ERCOT's Advanced Grid Support Proposal

Techno-economic Impact to Energy Storage Resources

Comments to ERCOT's Test Framework

Figure 4. The output active power of the resource and illustration of ΔE

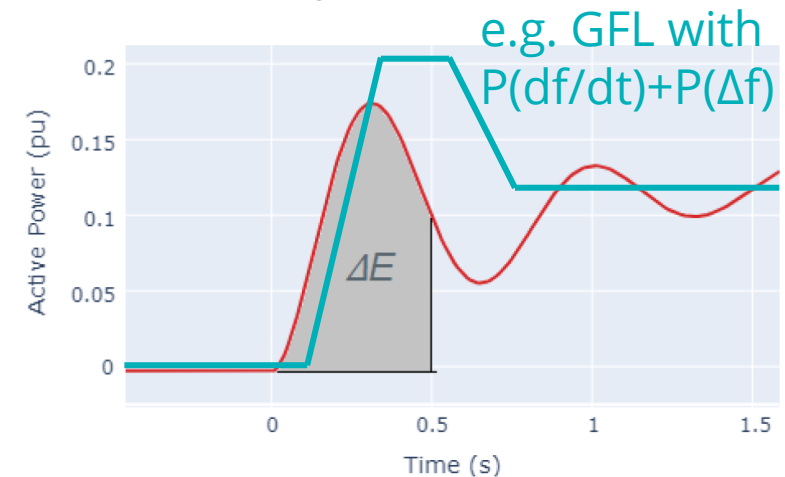
ΔE Criteria exposes ERCOT to Grid-Following controls with inherent deadtime from metering/controls/communications, which in turn lead to stability risks.
